Re: Partial Approval of MSD's 2012 Integrated Overflow Abatement Plan Project
Modification Request

2012 IOAP Project Modification

Subject: 2012 Integrated Overflow Abatement Plan (IOAP) Modification
DOJ Case No. 90-5-1-1-08254

Figure 1 - CSO AAOV Reduction Thru 2020

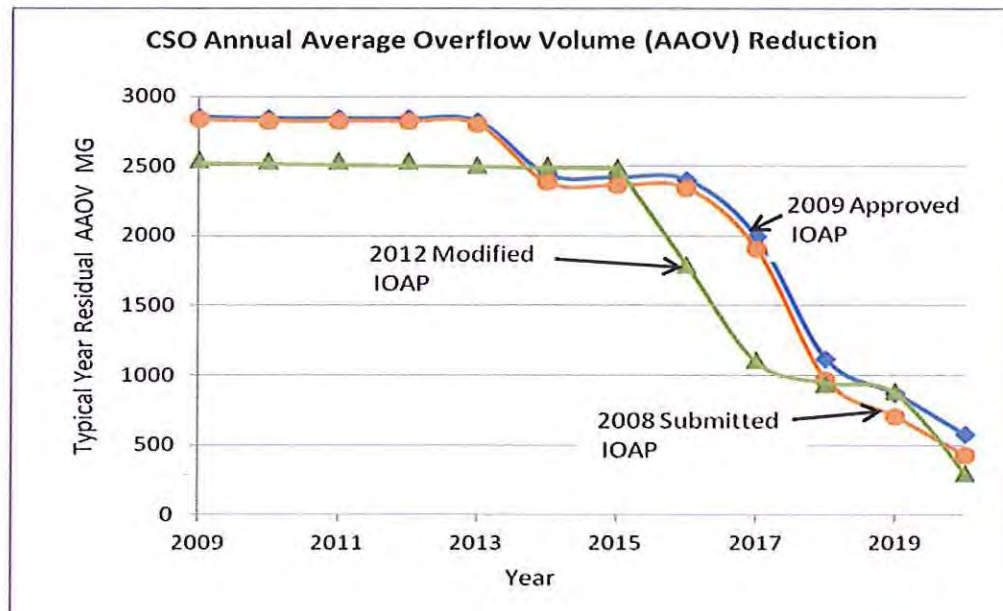
Note that Figure 1 shows three different overflow reduction curves. The curve labeled "2008 Submitted IOAP" illustrates the timing of AAOV reductions from the plan submitted in December 2008. The curve labeled "2009 Approved IOAP" illustrates a slightly different curve resulting from minor refinements made to a number of projects through the review, revision, and re-submittal process that occurred during January through September 2009. These minor refinements were documented in the project fact sheets submitted with the 2009 IOAP, but were not consistently reflected in the text. The 2012 IOAP Modification will correct the tables showing the 2009 IOAP and the 2012 IOAP Modification.

Figure 2 - SSO Reductions Thru 2024

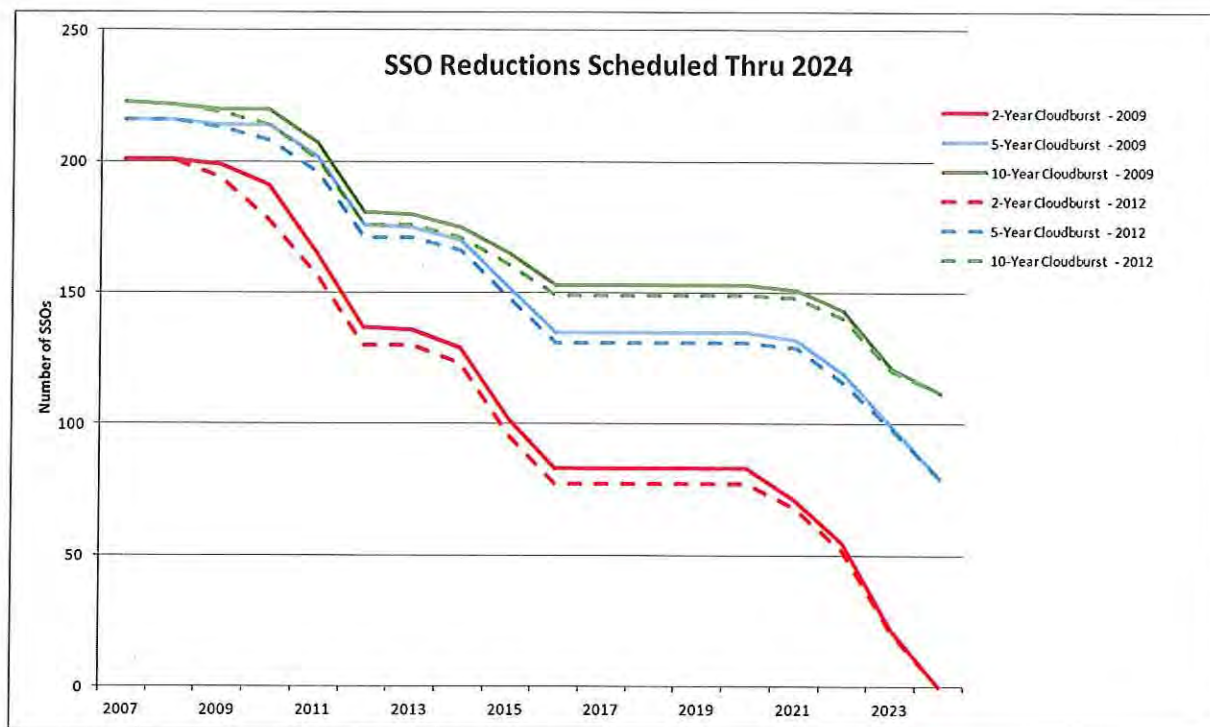
Figure 2 shows that the overall level of control for SSOs remains essentially the same as in the approved IOAP, but the SSO eliminations occur quicker than originally proposed for SSOs at all levels of control.

CSO140 Inline/Offline Storage

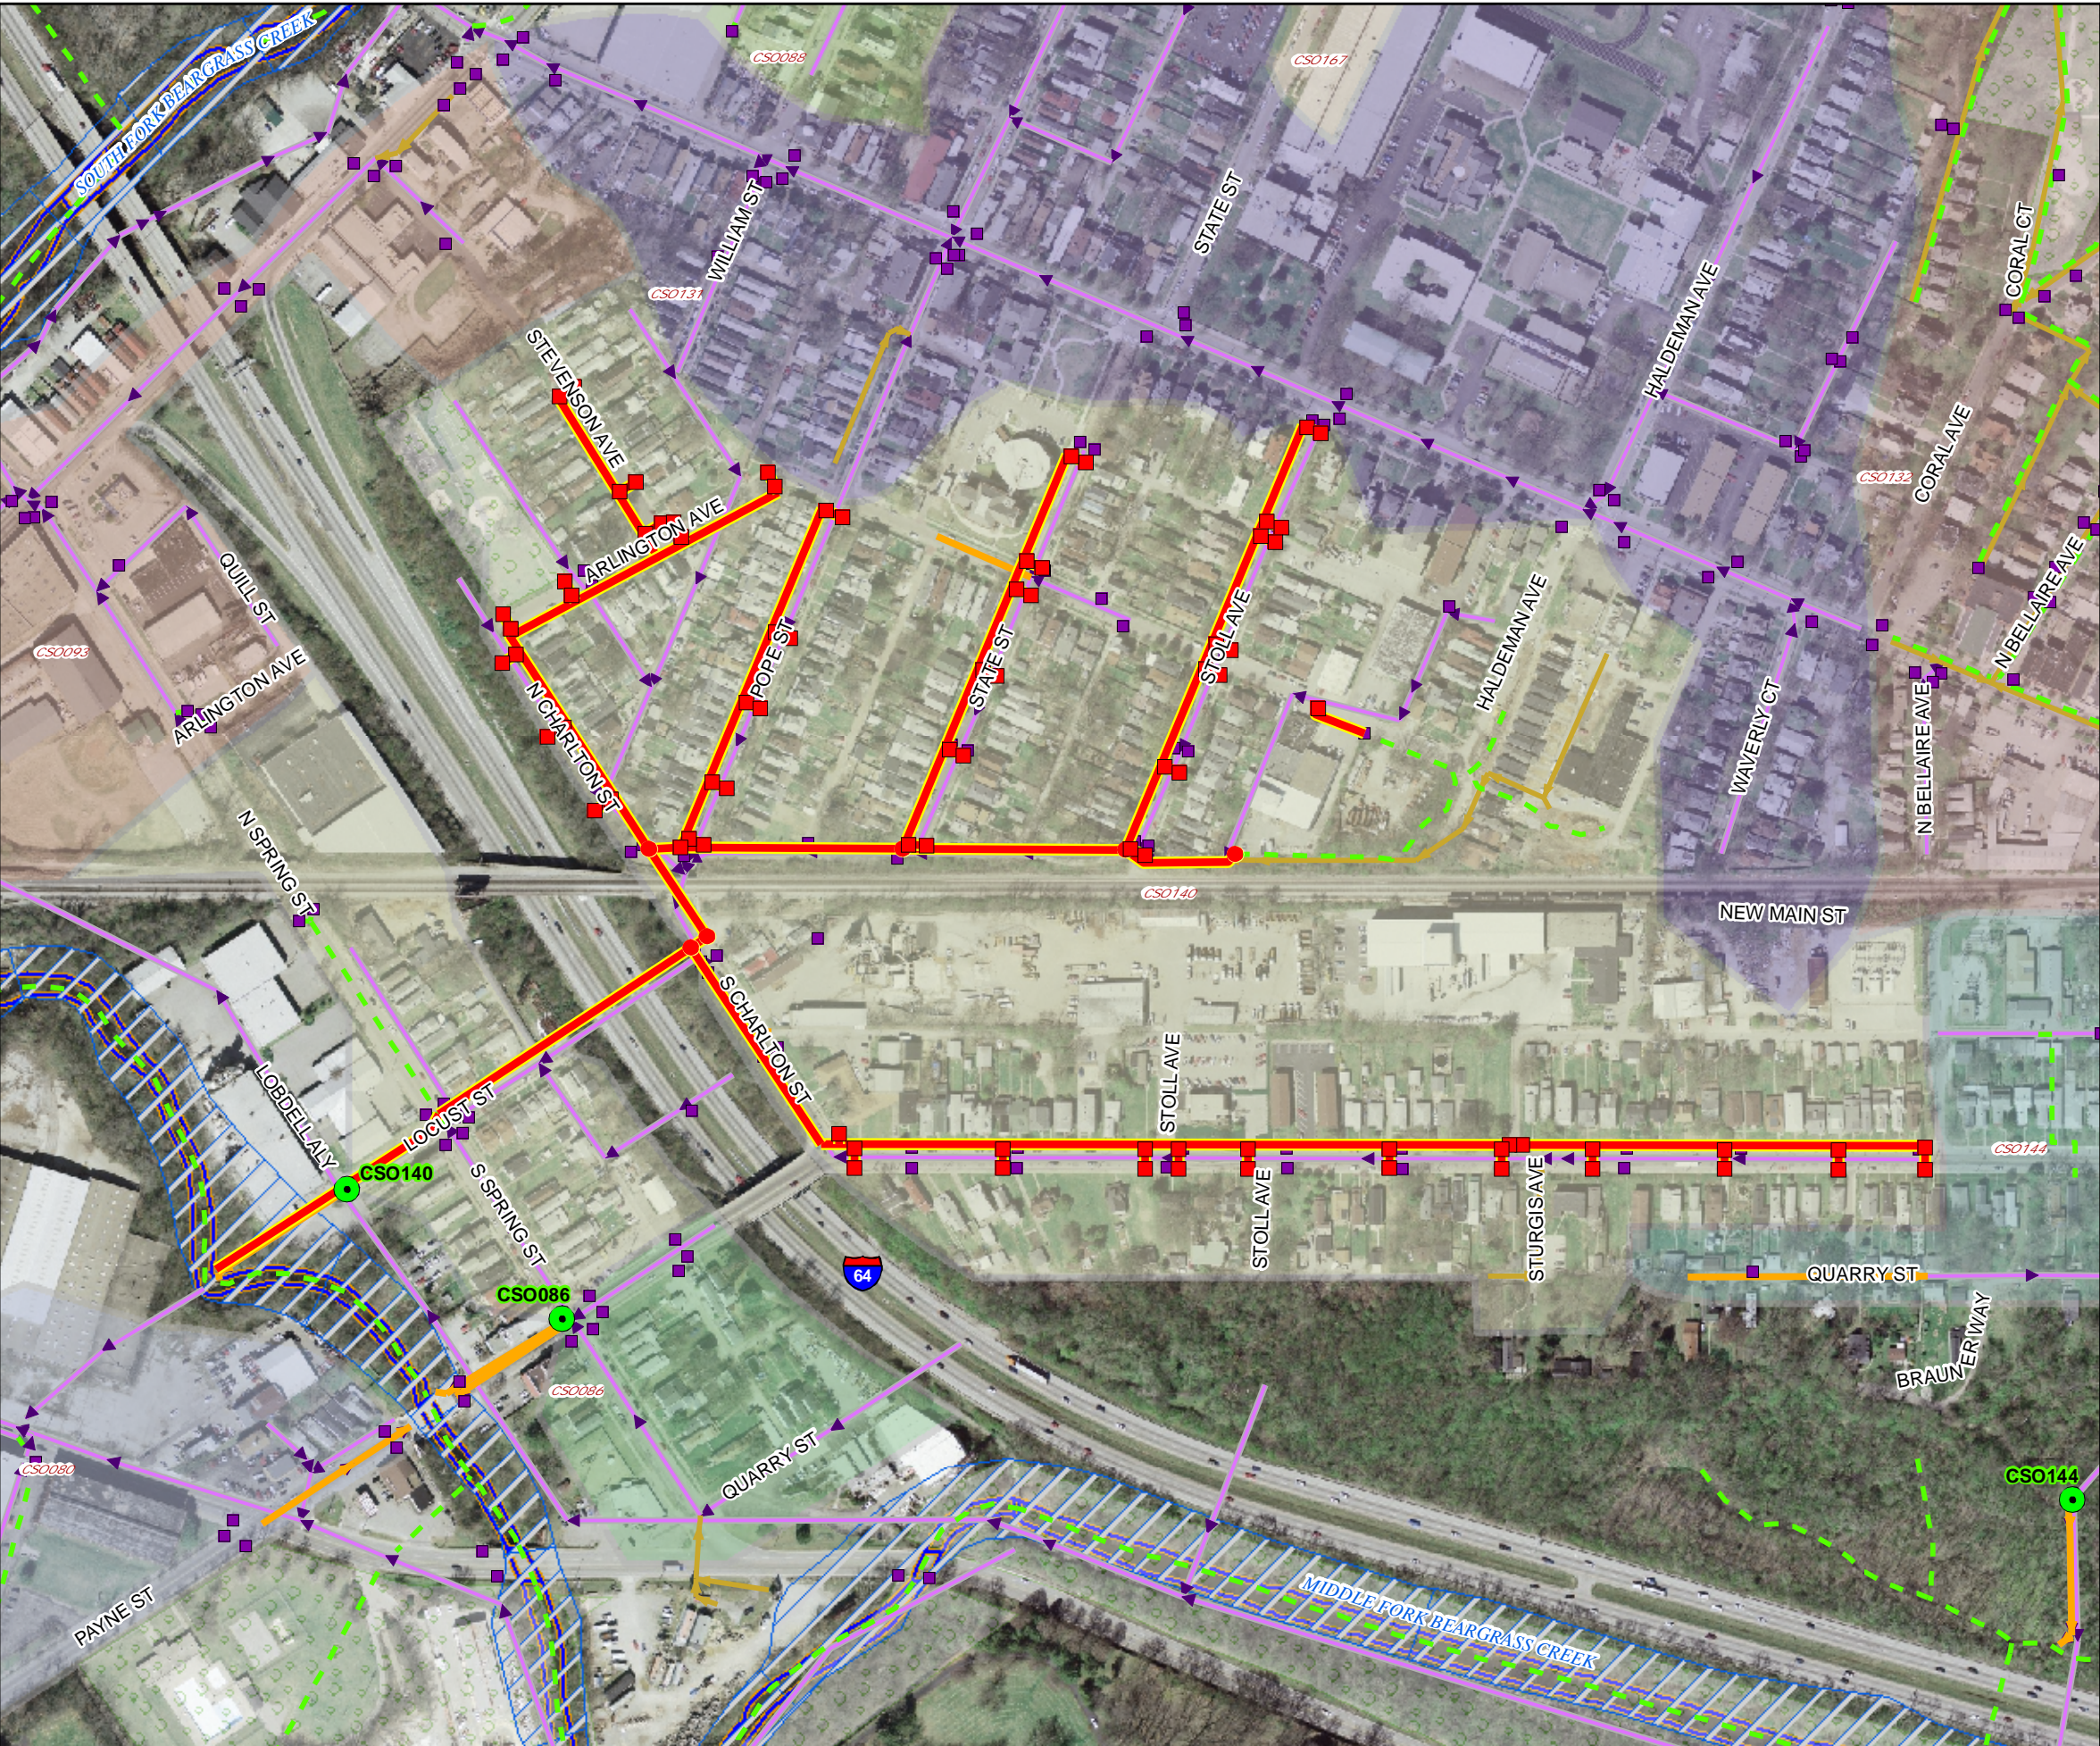
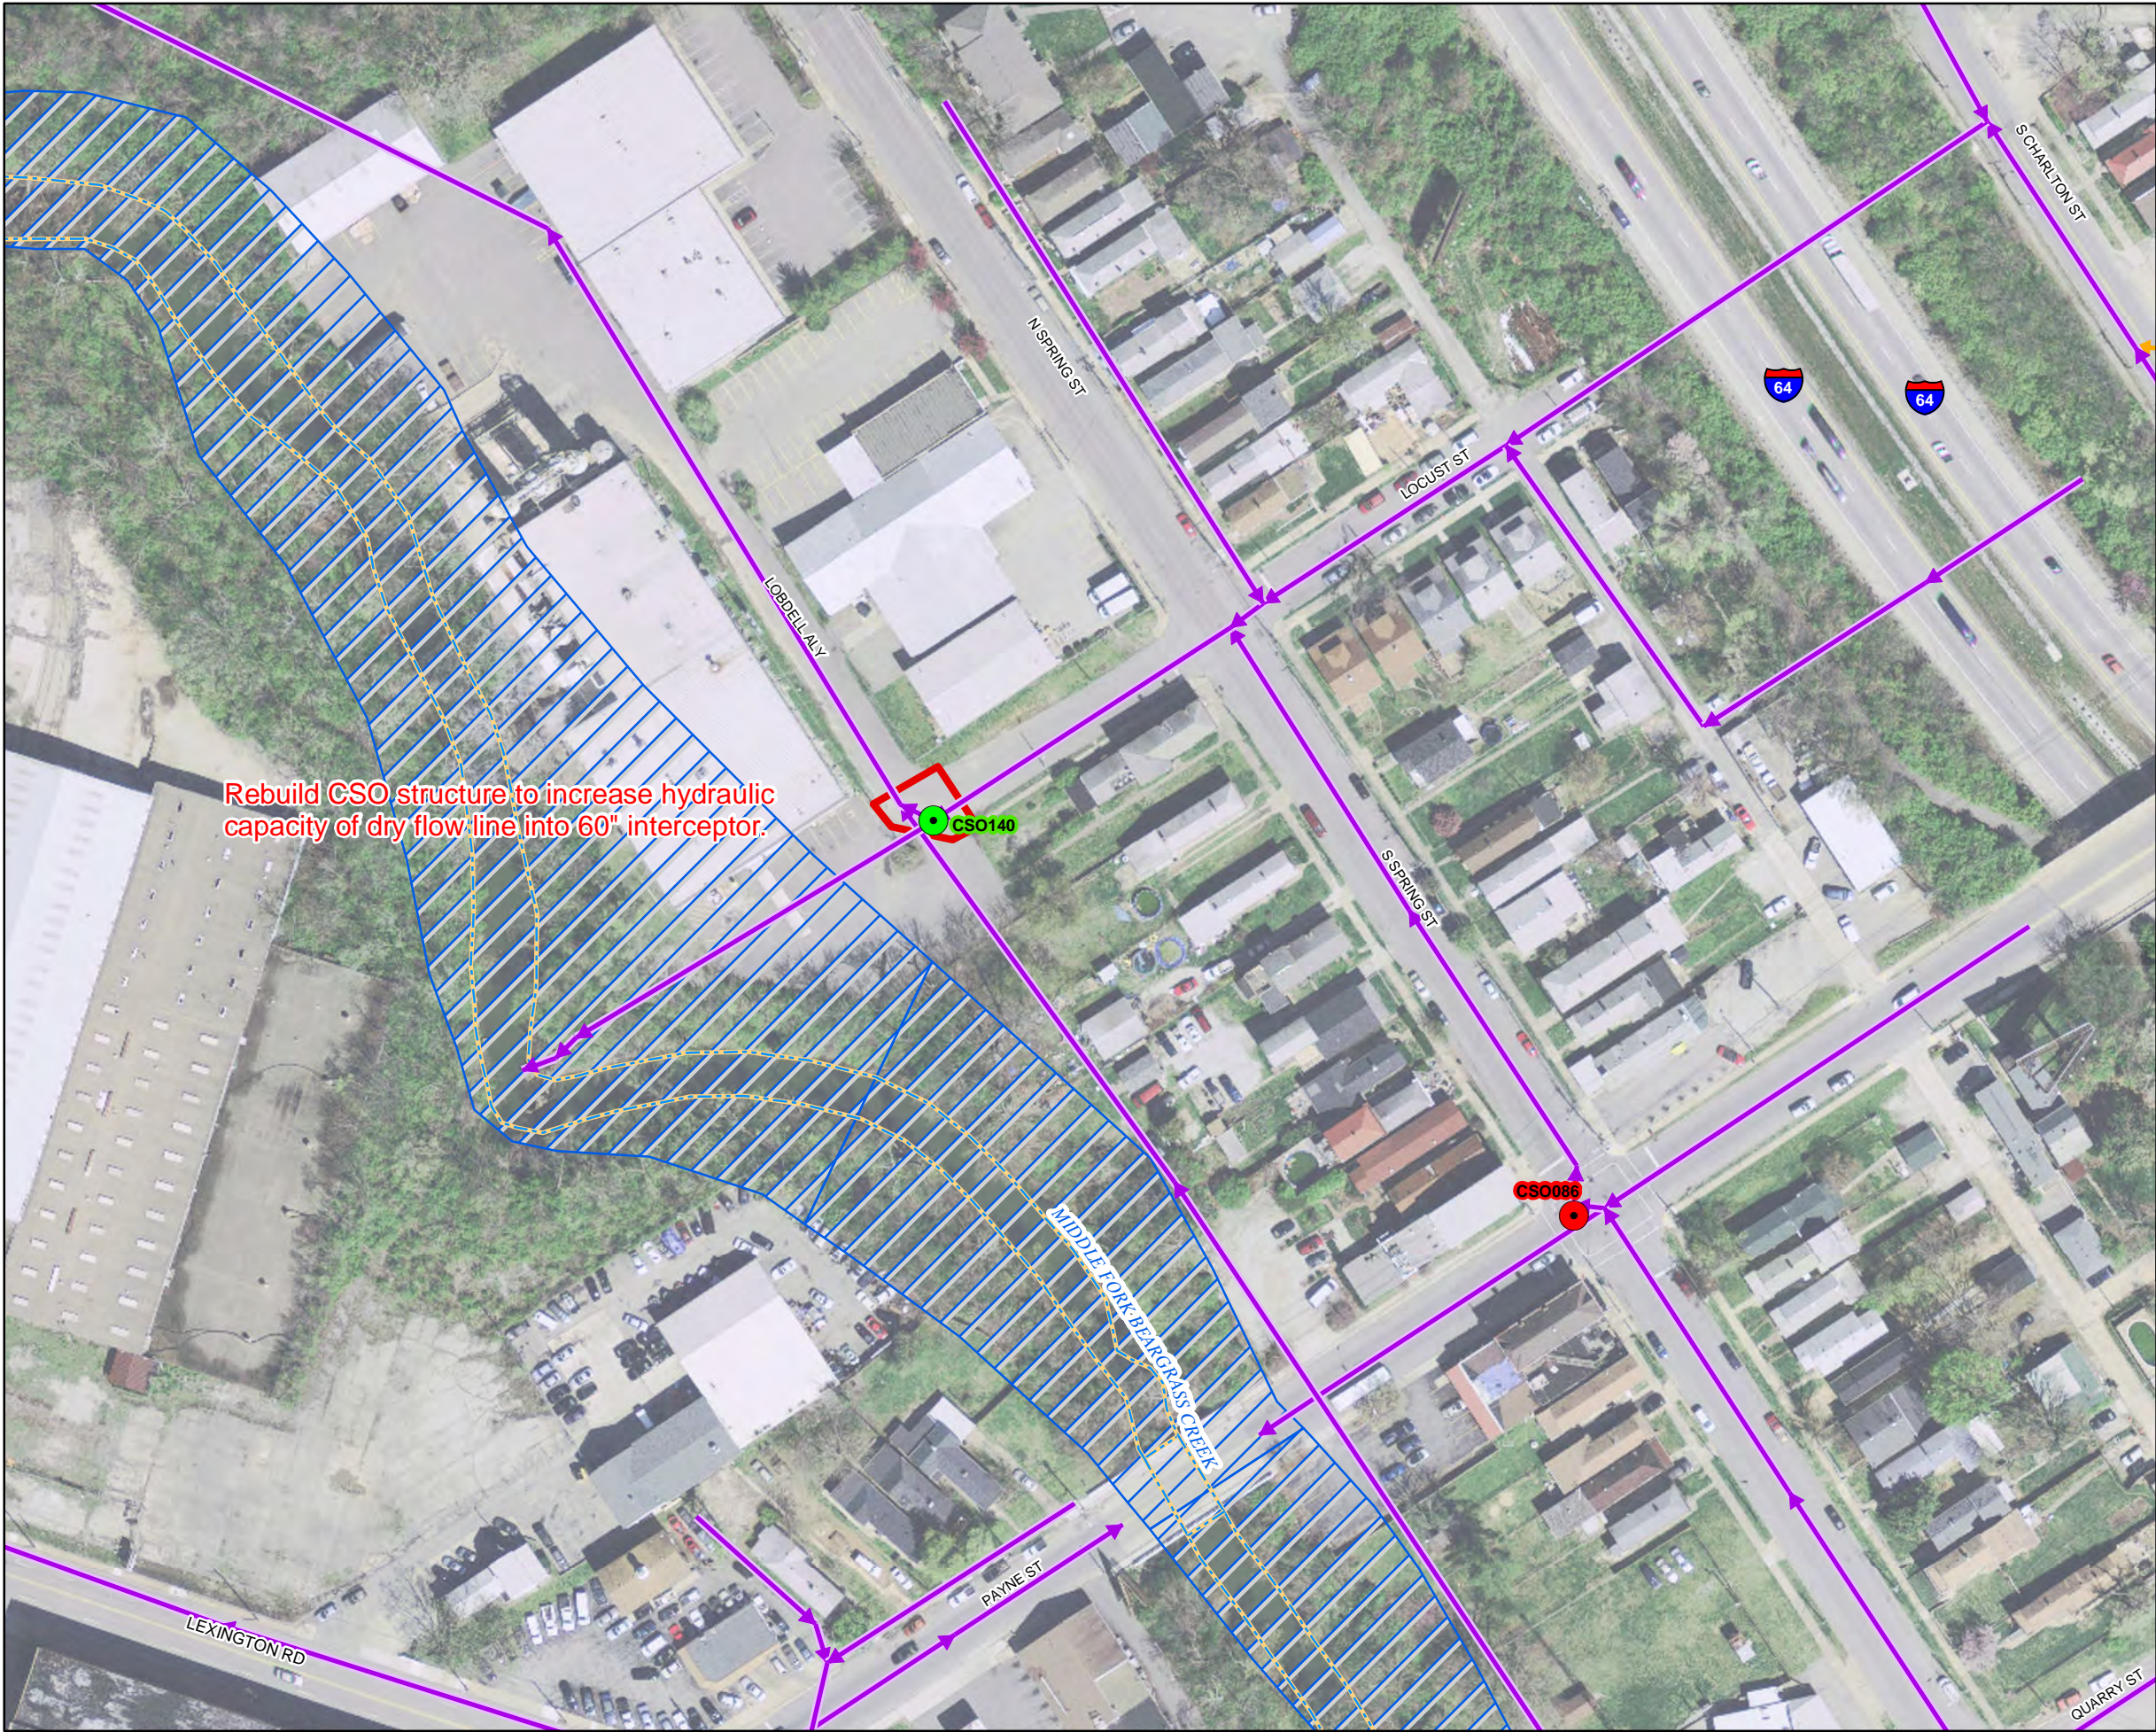
The project modification involves the re-construction of the CSO structure to increase the low flow line to a 42-inch diameter opening which will increase the conveyance capacity. The project completion date will remain at December 31, 2015, and level of control will be maintained at zero overflows in a typical year.
